<b>Subject:</b>  A-PILLAR TRIM DISTORTION	<b>Bulletin No:</b> 09-022/16
	<b>Last Issued:</b> 03/31/2016

2013-2016 CX-5 vehicles with VINs lower than JM3KE\*\*\*\*\*730190 (produced before Oct. 15, 2015)

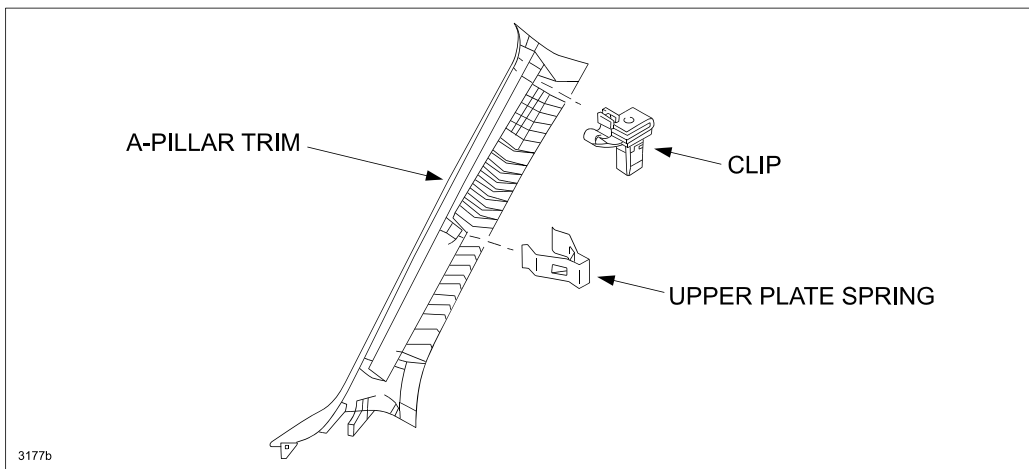
Some customers may complain of the poor appearance of the passenger and/or driver side A-pillar trim. The lower portion of the trim may become distorted (as shown below) due to high temperatures.

To eliminate this concern, the shape of the body flange has been improved during mass-production to allow sufficient A-pillar clearance.

1. Verify the customer concern.
2. Replace the affected side A-pillar trim(s) with a new modified service part according to the instructions on MS3 online or the Workshop Manual (section 09-17 A-PILLAR TRIM REMOVAL/INSTALLATION).
3. Verify the repair.

- The new service part has an aluminum reinforcement attached to the back side of the trim.
- The A-pillar trim comes with a clip and upper plate spring.
